1 Products affected

Enlarging of the fusedrawer slot.

DD11					0118.2182	
creation date	created by	release date	released by	notification no.	revision	page
2013-07-29	hollenpe	2013-12-04	hollenpe	25005		1 of 2

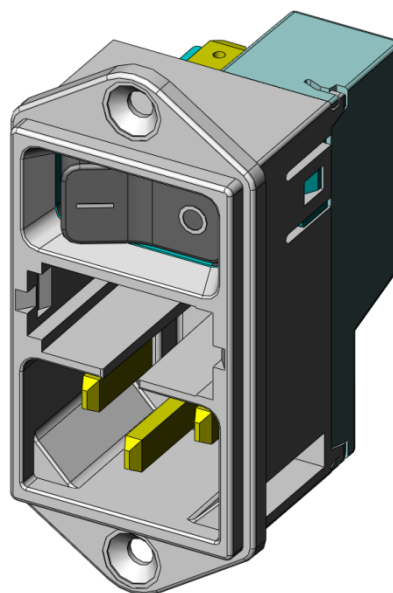
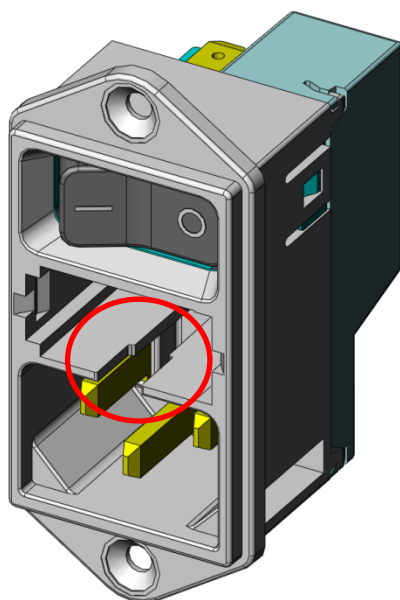
Fusedrawer slot enlarged.

Implementation of V-Lock cord retention function.
Precondition: new fusedrawer required (see PCN 0118.2133).

Form: New form is fully backwards compatible (can be used with old fusedrawer, see PCN 0118.2133).
Fit: n/a
Function: The new expanded slot allows applying V-Lock cord sets for cord retaining (new fuse drawer necessary).
Production Site: n/a
Product Label: n/a
